<b>To</b>	Cindy Luxhoj, City of Wilsonville
<b>From</b>	Jennifer Arnold, Emerio Design
<b>CC:</b>	Amy Pepper, City of Wilsonville
<b>Date</b>	October 17, 2023
<b>Subject</b>	DB23-0012 Canyon Creek South Site Design Review of Tract A – Incompleteness Letter Response

Items listed in the October 5, 2023, incompleteness letter will appear in *italics*, followed by the applicant’s responses in regular typeface.

TITLE : BENCH

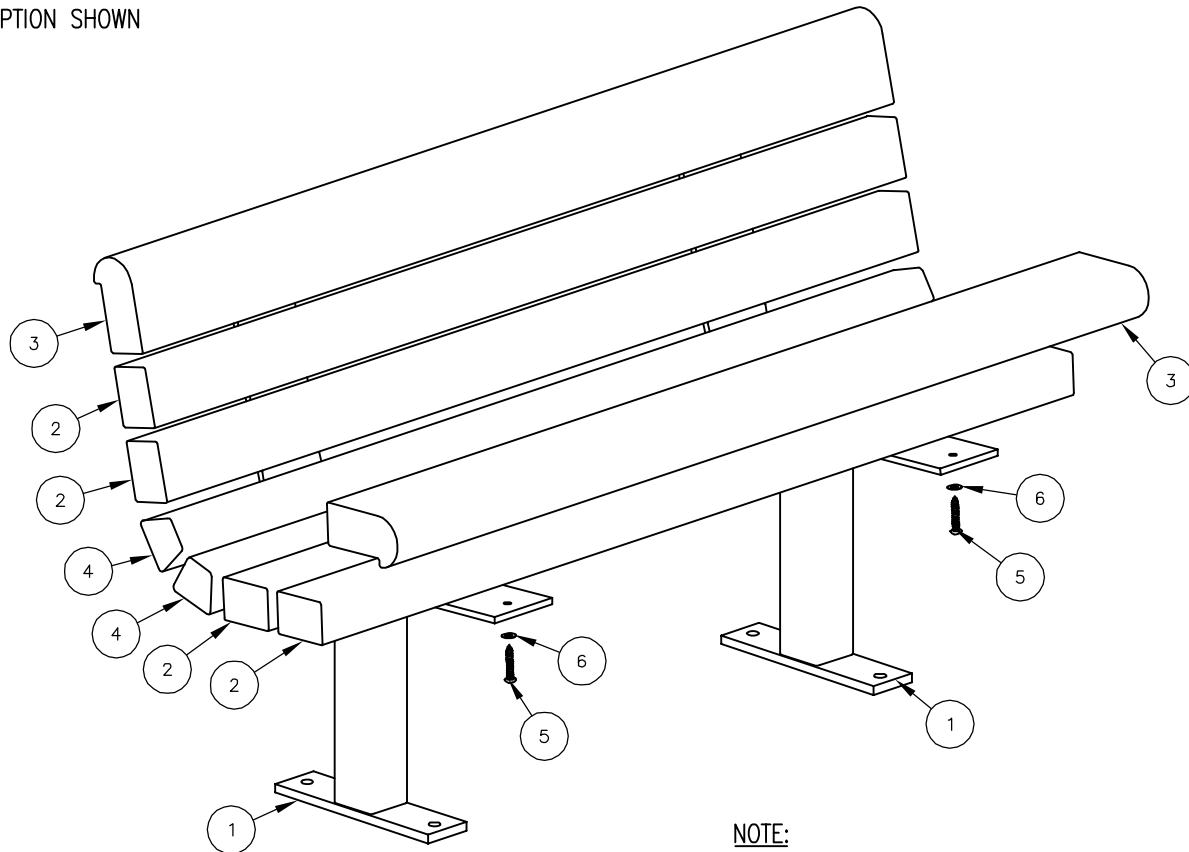
3. *Materials detail or cut sheet of the benches, picnic table, and any other site furnishings.*

**Applicant Response:** Included with Exhibit C are example images and detail sheets for both the picnic table and the benches. The example picnic table is intended to demonstrate material colors and materials but is not an ADA table as the detail specifies. The applicant proposes an ADA picnic table but had difficulty finding the appropriate image to match the detail.

**Exhibit D: Preliminary Plat Showing SROZ Boundary**

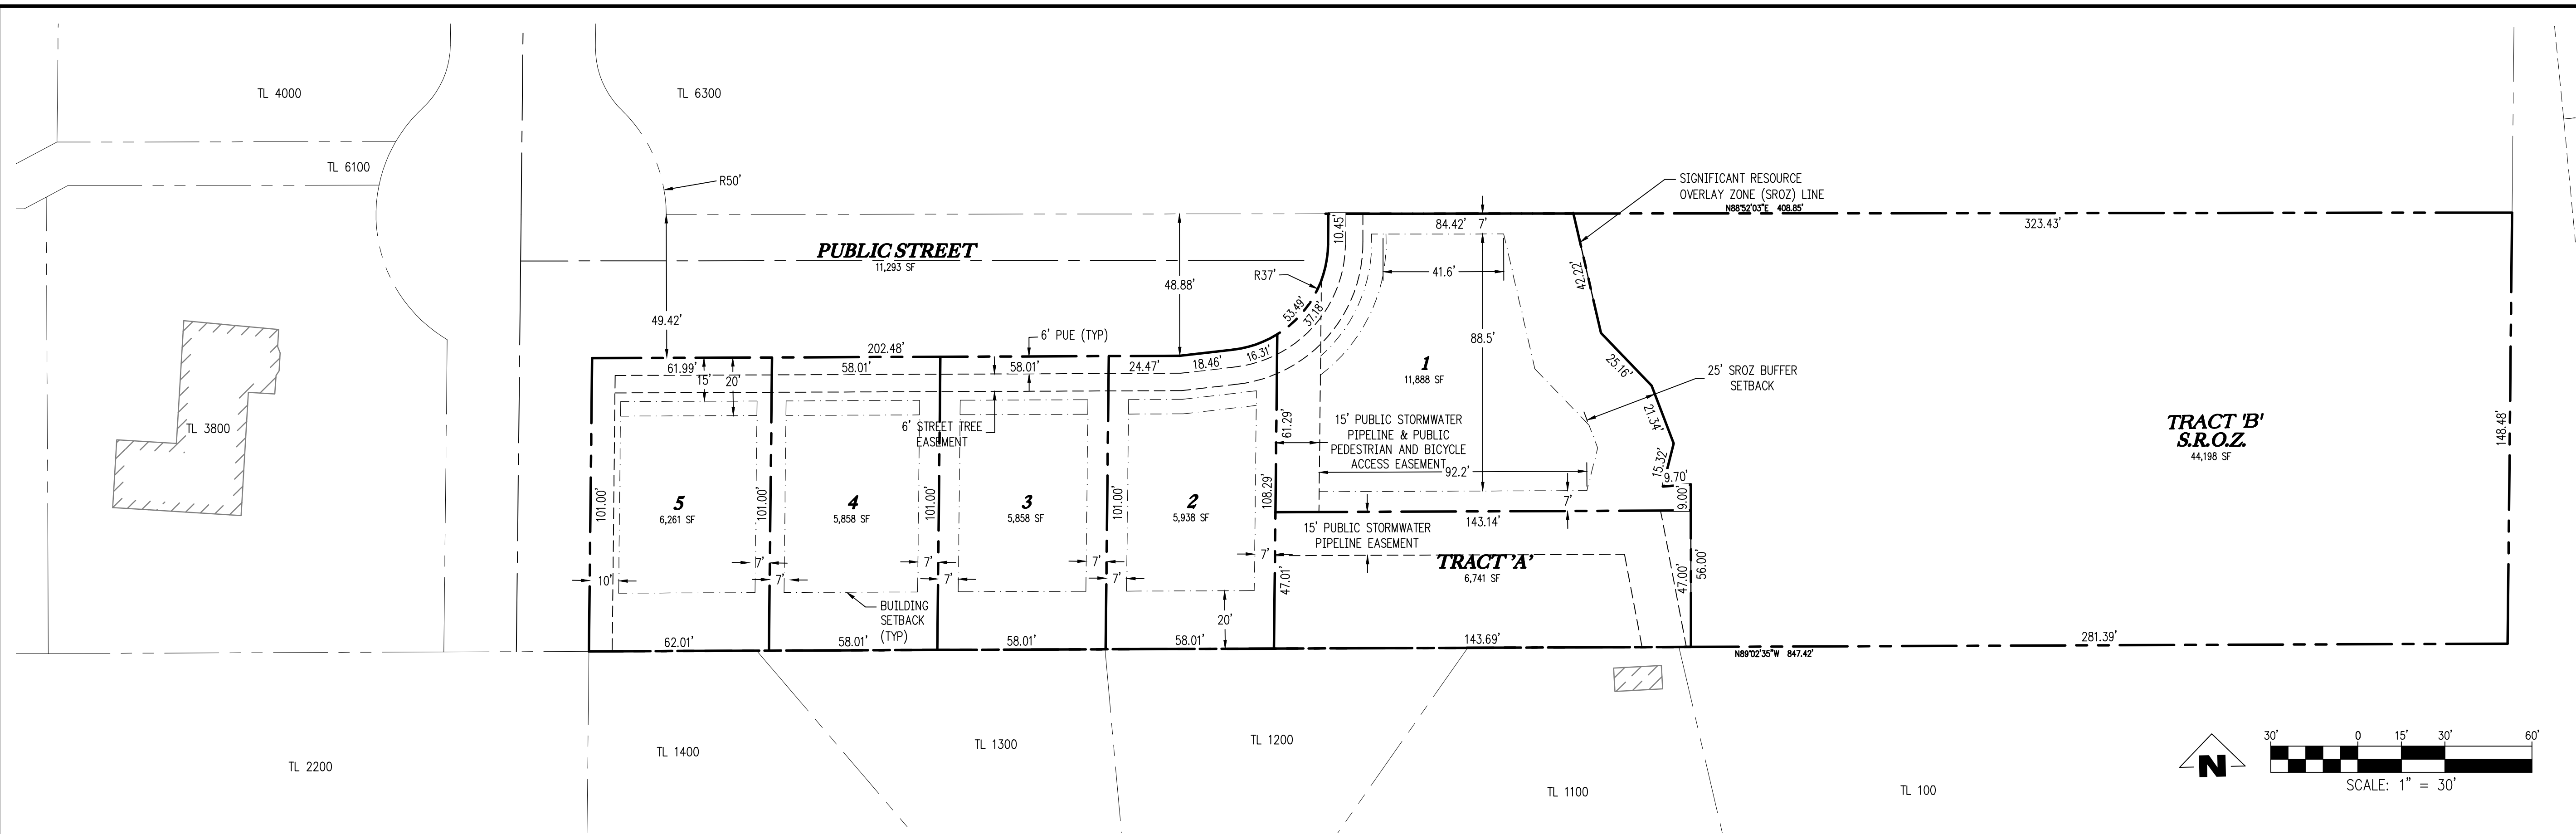
- Sufficient information indicating where the SROZ and Impact Area boundaries are in relation to the Tract A open space improvements, and demonstrating impacts to the SROZ and buffer zone, if applicable, and proposed impact mitigation. Demonstrate that only native plantings are proposed in the SROZ and Impact Area, if any, in the Tract A open space.*

**Applicant Response:** The eastern boundary of Tract A is the SROZ boundary, but this overlay has an associated 25 foot buffer which projects into Tract A. Within the 25 foot buffer from the eastern boundary, the applicant proposes to plant one new tree (Western Dogwood native cultivar) and a mix of several native cultivar shrubs and perennial grasses. See the submitted landscape plan for plant details. No structures, walls, impervious surfaces, or disturbances are proposed within the SROZ buffer area and certainly not in the SROZ protection Tract approved with the subdivision approval. Invasive plants within Tract A such as Himalayan blackberry are proposed to be removed and replaced with non-invasive plant materials.

**Exhibit D: Proposed Plat Showing Easements**

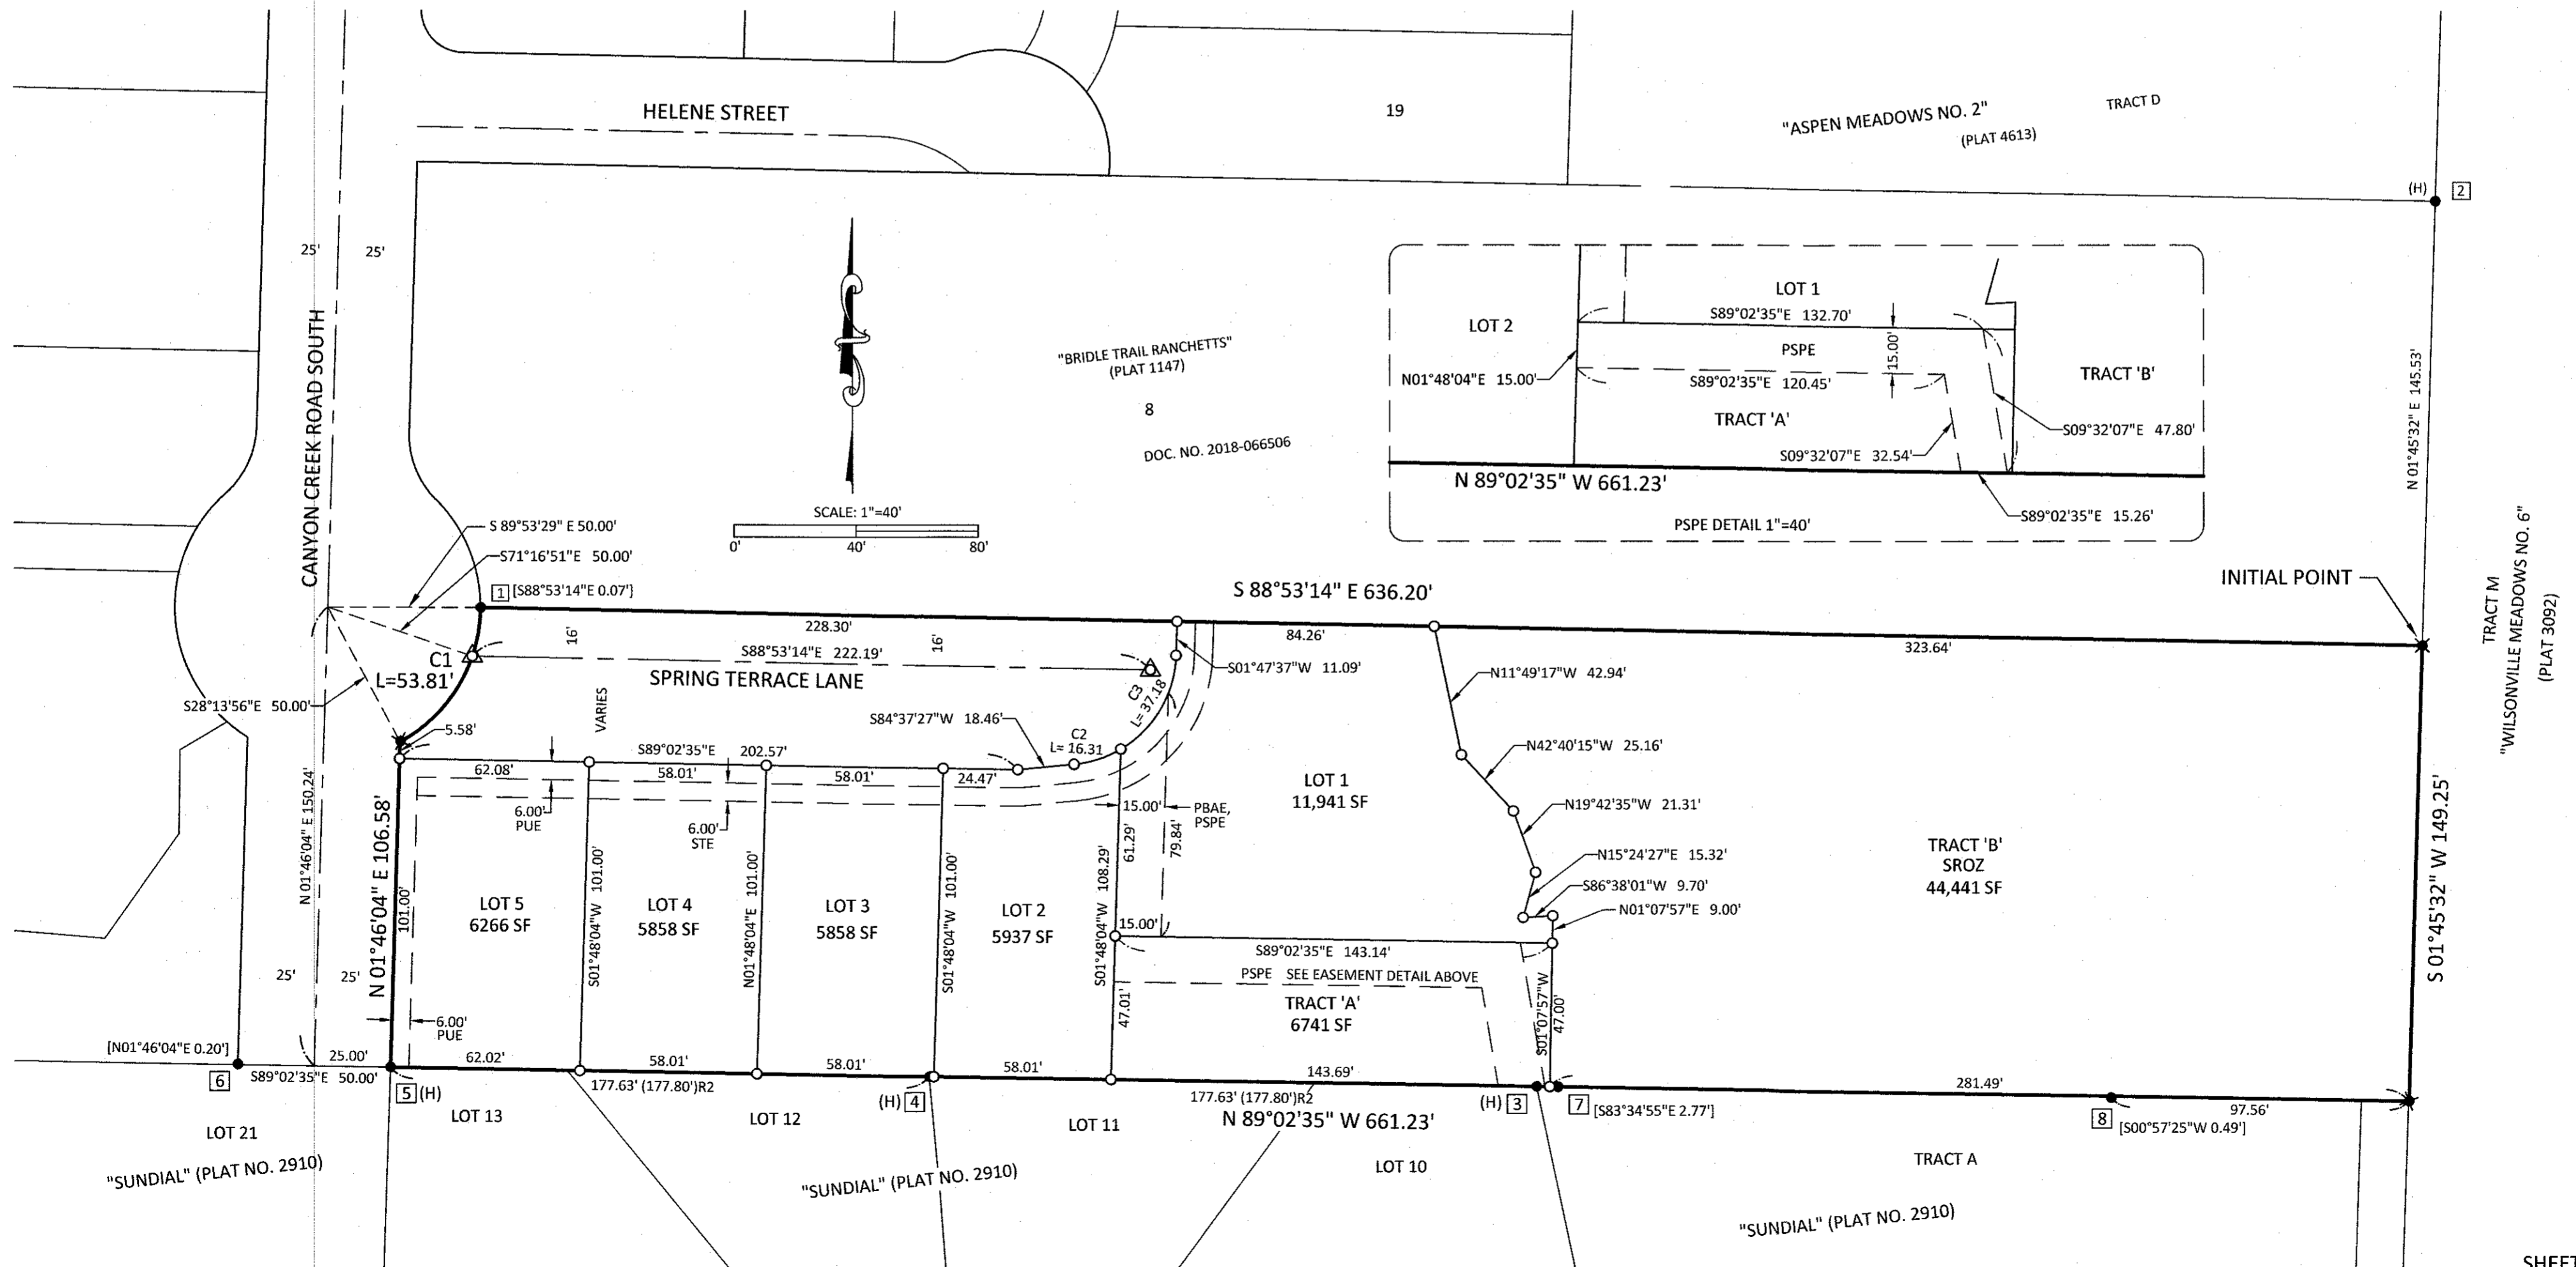
- Sufficient information provided about easements and dedications. Show the stormwater pipeline easement, public pedestrian and bicycles access easement, tree protection and preservation easement, and stormwater maintenance and access easements on the plans. No trees should be planted in the stormwater pipeline easement.*

**Applicant Response:** No trees are proposed to be planted within the stormwater pipeline easement as shown on the landscape plan. The stormwater pipeline easement is shown on the submitted grading plan and included in Exhibit D. Exhibit D also includes the plat with all easements noted and the SROZ boundary as shown on the preliminary plat. Tract A is intended to be a public space with easements to provide legal access and use.

**FENCE DETAIL**

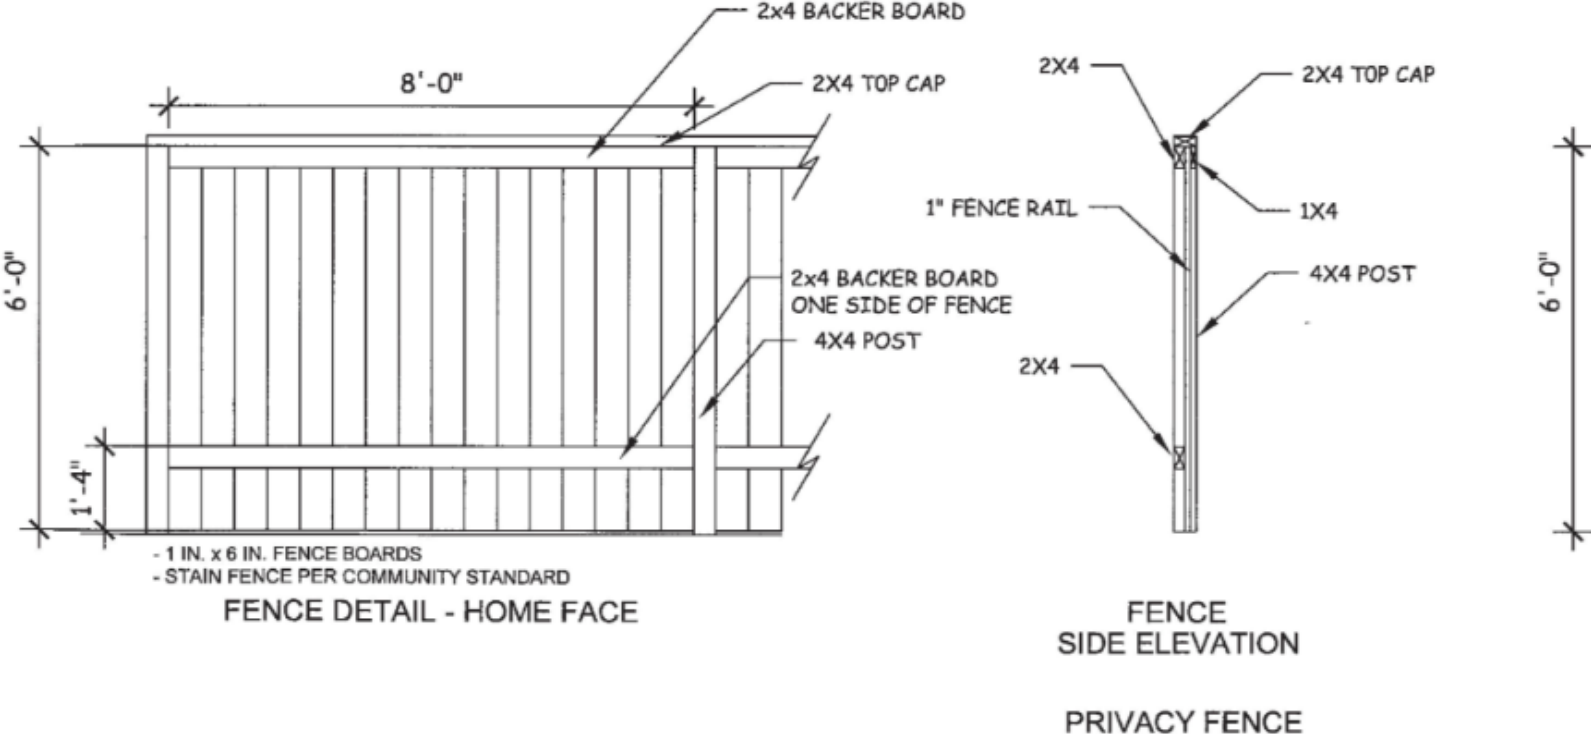
4. *Materials detail or cut sheet of the perimeter/privacy fencing, indication of where the fence will be located around the open space, and explanation of why this is necessary.*

**Applicant Response:** See Exhibit F for fence detail information. The applicant has proposed constructing a fence along a portion of the southern boundary of Tract A to benefit the property owners on TL1100. The existing neighbor on TL 1200 has an existing wooden privacy fence and the applicant does not propose any change to that existing fence. This will create a continuous fence along the southern boundary of Tract A which will provide safety and privacy screening. This was not an agreement made based on a requirement of the Wilsonville Development Code but out of a good faith effort to work with the adjacent property owners given the ongoing disturbance associated with construction.
